File: board.kicad_pcb

Title: NanoE-DMX

Rev: 0.1

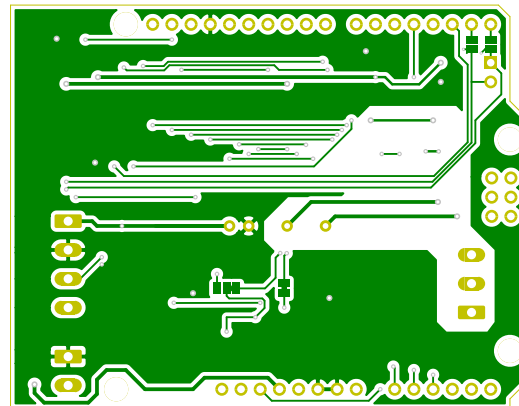
DO NOT USE: in revision only minor mistakes are fixed.
ERROR: U1 has a wrong footprint, which requires a larger rerouting.
DRC ignore courtyards overlap R130-134/U30

Title: NanoE-DMX

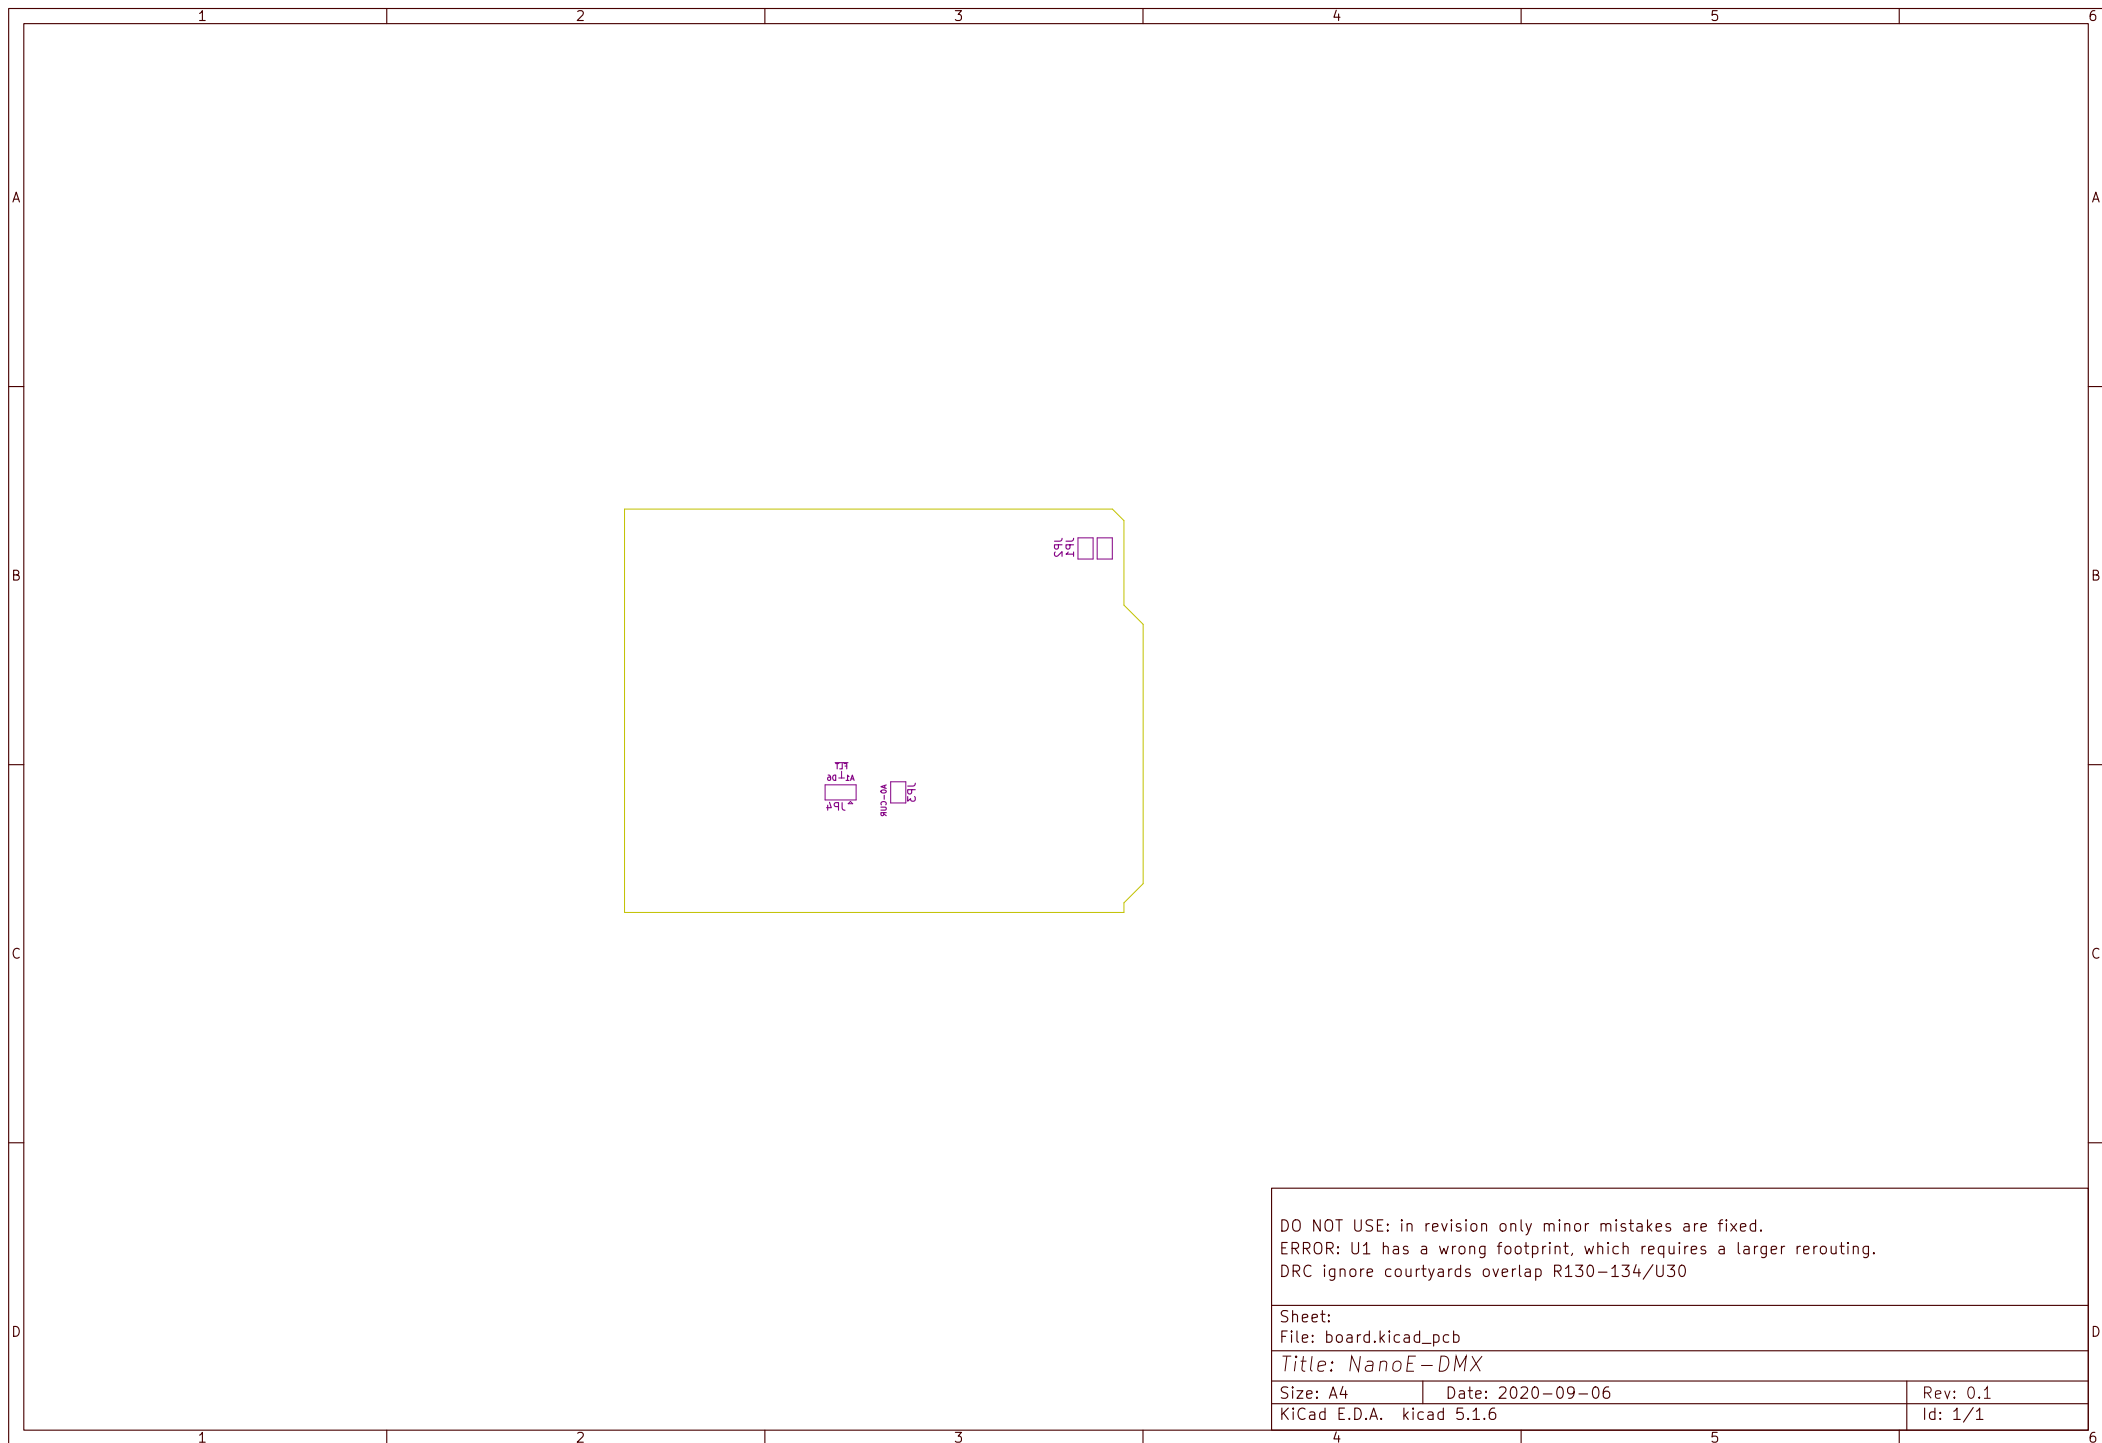
DO NOT USE: in revision only minor mistakes are fixed.
ERROR: U1 has a wrong footprint, which requires a larger rerouting.
DRC ignore courtyards overlap R130-134/U30
